Subject:       Huntington Beach Seawater Desalination Facility Groundwater Model  
                  Evaluation

## Huntington Beach Seawater Desalination Facility Groundwater Model Evaluation

HydroFocus, Inc., Davis, CA  
September 23, 2016

Figure 1. Effects of changes to the Talbert Aquifer hydraulic conductivity on inland flow (a), wetland flow (b), and mean Layer 8 water level decline (c).

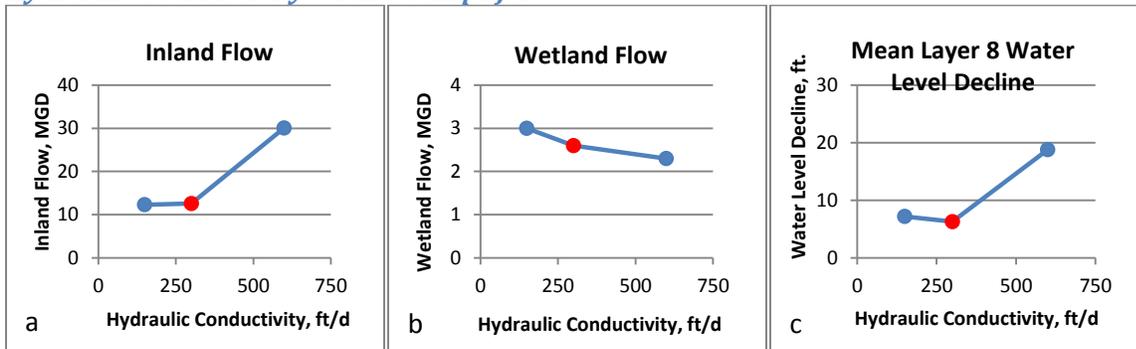
Model results are more sensitive to increases in the hydraulic conductivity of the Talbert Aquifer than to decreases. Specifically, a 100% increase in the horizontal and vertical hydraulic conductivity (these parameters were varied together) of the Talbert Aquifer resulted in significant increases in flow from the inland boundary (140%) (Figure 1a) and Layer 8 water level decline (200%) (Figure 1c). Decreasing the horizontal and vertical hydraulic conductivity by 50% had a minimal effect on inland flow and water level decline (-2% and 14%, respectively) (Figures 1a and 1c). Increasing and decreasing the hydraulic conductivity of the Talbert aquifer resulted in minimal changes to the wetland flow (-12 to 15%) (Figure 1b).

Figure 2. Effects of changes to the hydraulic conductivity in the layers overlying the Talbert Aquifer on inland flow (a), wetland flow (b), and mean Layer 8 water level decline (c).

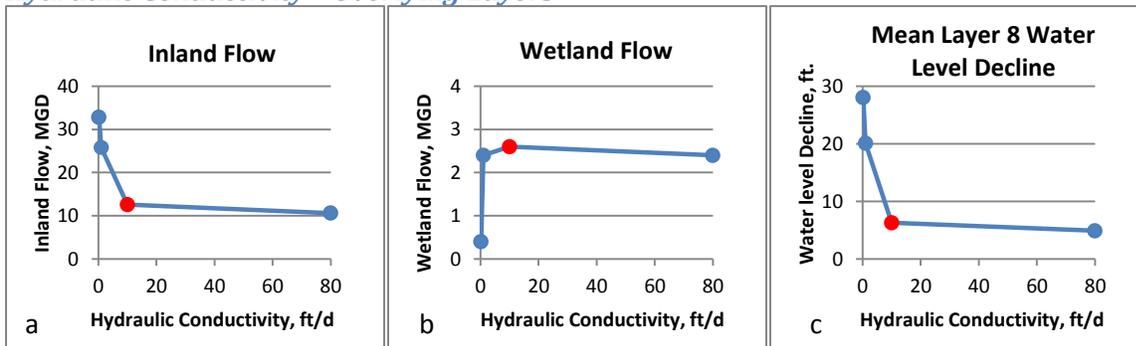
The horizontal and vertical hydraulic conductivity in the model layers overlying the Talbert Aquifer was decreased and increased. Inland flow changed as much as 160% (Figure 2a) and wetland flow changed as much as -85% (Figure 2b) due to decreasing the hydraulic conductivity from 10 ft/d to 0.2 ft/d. Layer 8 water level decline was most sensitive to decreasing the hydraulic conductivity of the overlying layers (220% to 340% change in water level declines) (Figure 2c). Inland flow was also most sensitive to decreasing the hydraulic conductivity. Changes to inland and wetland flow and Layer 8 water level decline were relatively insensitive to increasing hydraulic conductivity.

Figure 3. Effects of changes to the hydraulic conductivity in the layers underlying the Talbert Aquifer on inland flow (a), wetland flow (b), and mean Layer 8 water level decline (c).

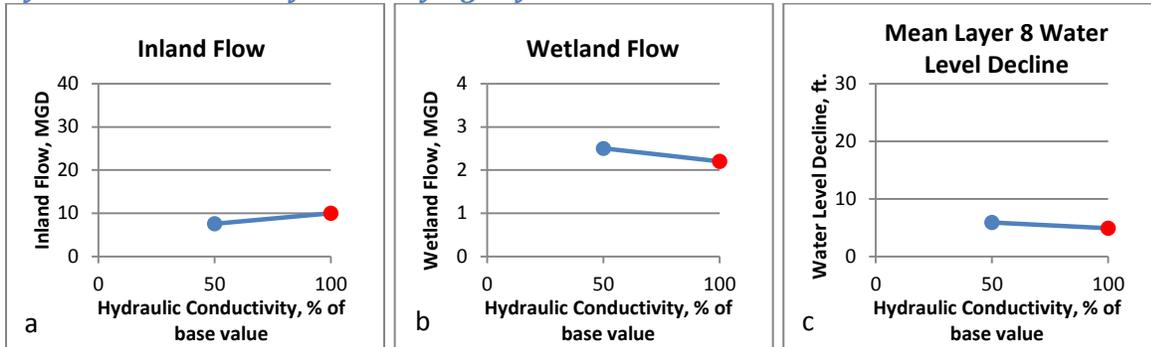
The results shown in Figures 3 through 5 were for model runs in which the specified pumping rate was 100 MGD. A 50% decrease in the hydraulic conductivity of the layers underlying the Talbert Aquifer

resulted in relatively small changes of -24%, 14%, and 20% change in inland flow, wetland flow, and Layer 8 water level decline, respectively (Figures 3a, 3b, and 3c).

Figure 4. Effects of slant well screen length on inland flow (a), wetland flow (b), and mean Layer 8 water level decline (c).

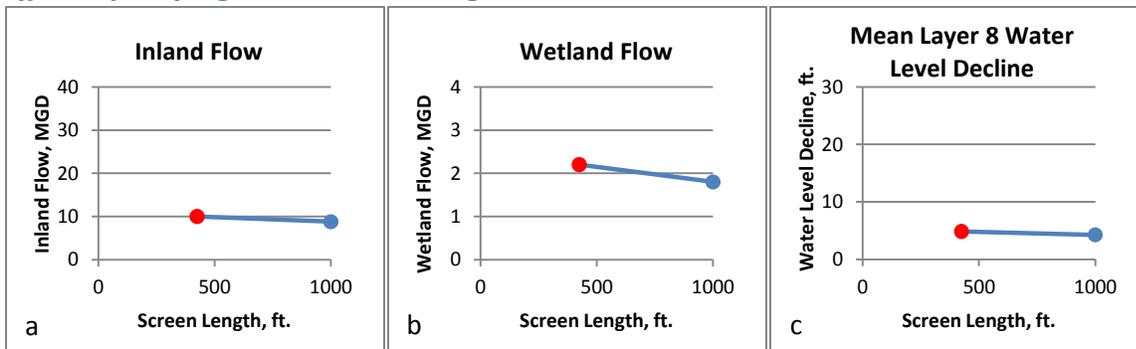
The slant well screen was lengthened and extended farther offshore than the 425-ft well screens used in the base run. These runs were conducted using a pumping rate of 100 MGD. A 135% increase in the well screen length resulted in relatively small changes of -12%, -18%, and -12% changes in inland flow, wetland flow, and Layer 8 water level decline, respectively (Figures 5a, 5b, and 5c).

**Figure 5. Effects of barrier head elevation on inland flow (a), wetland flow (b), and mean Layer 8 water level decline (c).**

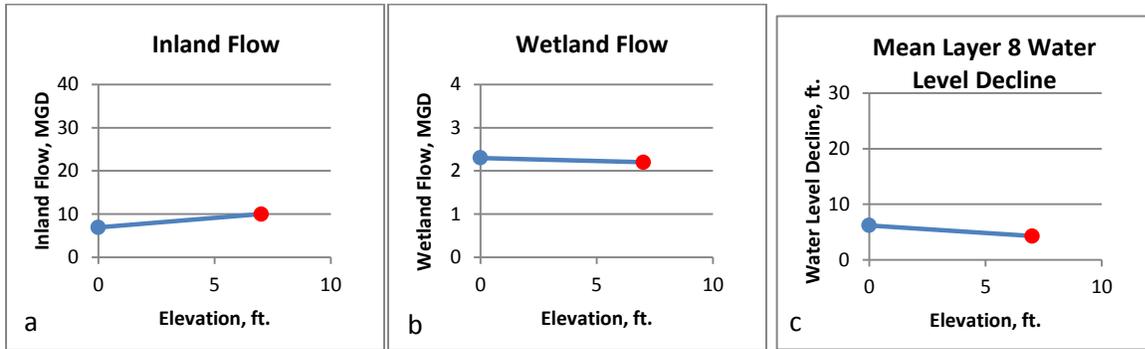
The water levels specified in the constant head cells representing the seawater intrusion barrier were reduced from the base value (about 7 ft. in Layers 2-8, 10 ft. in Layers 9-10) to 0 ft. in all layers. Because slant well pumping would likely reduce sea water intrusion, lower water levels at the Talbert Gap seawater intrusion barrier will likely result in an effective barrier. These runs were made using a pumping rate of 100 MGD. The change in the barrier water level resulted in a -31%, 5%, and 29% change in inland flow, wetland flow, and Layer 8 water level decline, respectively (Figures 5a, 5b, and 5c).

**Figure 6. Effects of changes to the slant well pumping rates on inland flow (a), wetland flow (b), and mean Layer 8 water level decline (c).**

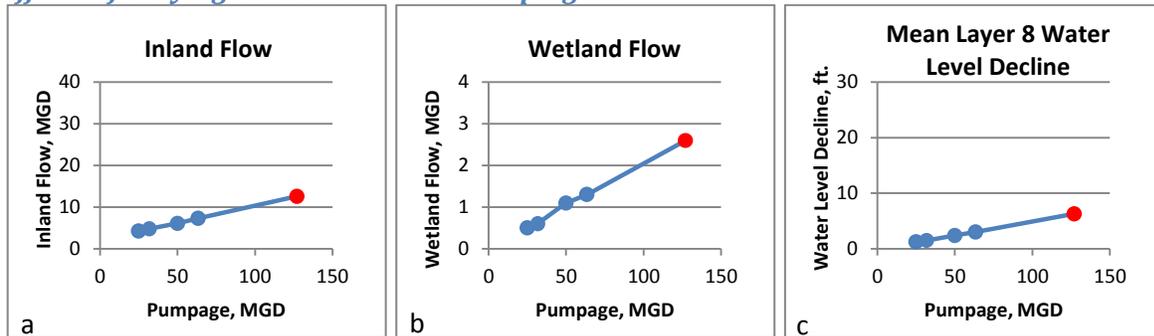
Inland and wetland flow and Layer 8 water level decline are linearly related to the slant well pumping rate. Decreases in the slant well pumping rate result in corresponding decreases in inland and wetland flow and water level decline. The relative impact of reduced pumping is greater on the wetland flow (Figure 6b) and Layer 8 water level decline (Figure 6c) (up to -81% change) than on inland flow (Figure 6a) (up to -67% change).

**Figure 7. Effects of slant well location on inland flow (a), wetland flow (b), and mean Layer 8 water level decline (c).**

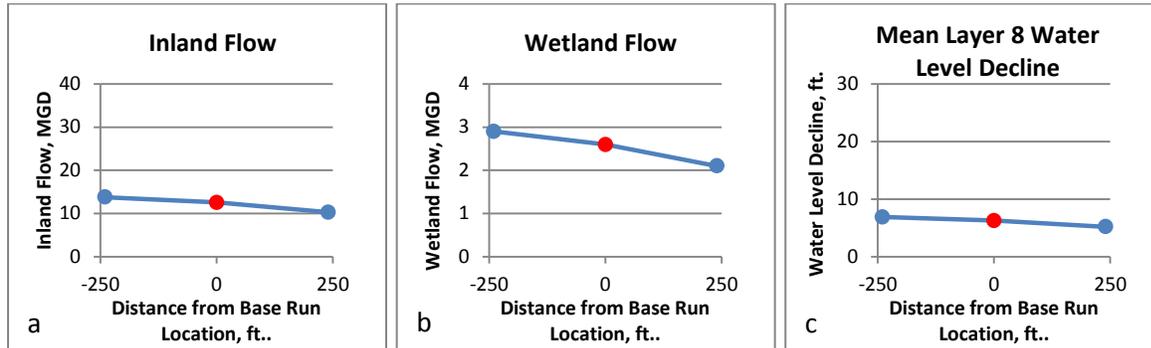
The location of the slant wells were moved both farther inland and farther seaward relative to the location used in the base run. The run with the well location farther inland is shown as a negative distance and the run with the well location farther seaward is shown as a positive distance from the base run location, respectively (Figures 7a, 7b, and 7c). Moving the wells farther inland resulted in relatively small changes of 10%, 12%, and 10% change in inland flow, wetland flow, and Layer 8 water level decline, respectively. Moving the wells farther seaward resulted in relatively small changes of -18%, -19%, and -17% in inland flow, wetland flow, and Layer 8 water level decline, respectively.

Figure 8. Groundwater flow paths to the slant wells.

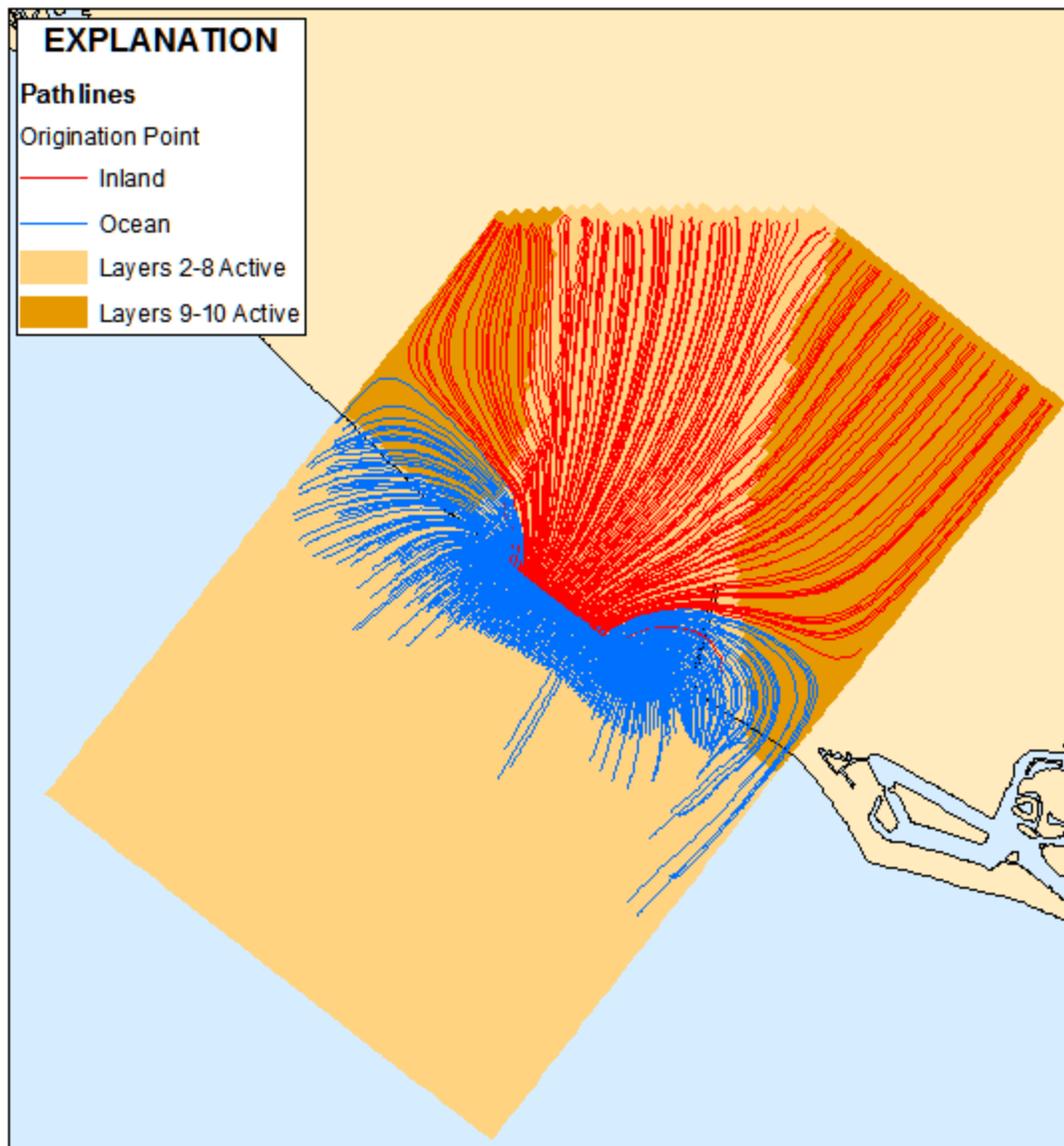
Figure 8 shows the groundwater flow paths to the slant wells (Geosyntec model 6, 127 MGD slant-well pumping rate). Eighty-seven percent of the groundwater flow pathlines originate in the ocean and 13 percent originate inland. This is similar to the percentage of flow to the slant wells from the ocean and from inland (wetlands and intrusion barrier). Average travel time for the groundwater flow pathlines that originate near the intrusion barrier is about 20 years. Using a pumping rate of 63.5 MGD (one-half the base rate of 127 gpm) increased the Talbert Aquifer travel time from the barrier to the slant wells to about 37 years. Using the base pumping rate of 127 MGD and setting the barrier constant heads to 0.0 ft. results in an average travel time in the Talbert Aquifer of 24 years.

Many of the pathlines in Figure 8 extend from the slant wells to the northwest and southeast toward the lateral boundaries of the model and turn sharply toward the ocean or the constant head cells representing the barrier. This sharp turn in some pathlines suggest that the simulated groundwater flow paths are being affected by the lateral extent of the model, primarily in Layers 9 and 10.

- Groundwater flow paths suggest that the model results may be affected by the lateral extent of the model domain.

- Conduct aquifer tests or pilot well pumping to determine hydraulic conductivity values in the Talbert Aquifer and overlying sediments.
- Hydraulic conductivity values of wetland sediments should also be determined.
- Assess effects of lateral model boundary conditions on model results and modify as needed.
- Inconsistencies in model construction (cell size, variable head cells in the ocean, etc.) should be resolved to eliminate any concern that these issues may affect model results.
- Incorporate MODFLOW Subsidence Package to preliminarily evaluate the subsidence potential due to slant well pumping.

Figure 9. Relation of pumping rate and inland flow.

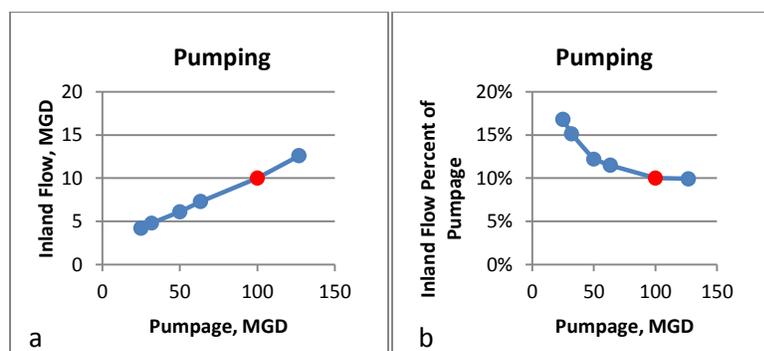
Model runs using varying pumping rates may potentially be used to select the optimum pumping rate to minimize the proportion of pumping originating as inland flow. The volume of water originating as inland flow is directly proportional to the pumping rate (Figure 9a). However, the percent of the pumping volume that originates as flow from the inland barrier is not directly proportional (Figure 9b). As the pumping increases, the percentage of the pumping that originates as inland flow decreases. At pumping rates of 63.5 MGD and above, the percentage of pumping that originates as inland flow does not change significantly and is about 10%.

The sensitivity results show that the specified aquifer properties and other model inputs affect the calculated percent of the simulated slant well pumping that originates as inland flow. For example, using a pumping rate of 127 MGD, doubling the hydraulic conductivity of the Talbert Aquifer increased the percent of pumping that originates as inland flow from 10% to 24%. Likewise, decreasing the hydraulic conductivity of the material overlying the Talbert aquifer up to 98% increased the percent of pumping that originates as inland flow from 10% to 26%. Using a pumping rate of 100 MGD, increasing the hydraulic conductivity of the material overlying the Talbert Aquifer or decreasing the hydraulic conductivity of the material underlying the Talbert Aquifer decreased the percent of pumping that originates as inland flow from 10% to 9% and 8%, respectively. Combining several changes to model input (increasing slant well length, increasing the hydraulic conductivity of the overlying material, decreasing the hydraulic conductivity of the underlying material, and lowering the water level maintained at the barrier) resulted in 4% percent of the slant-well pumping originating from inland flow.
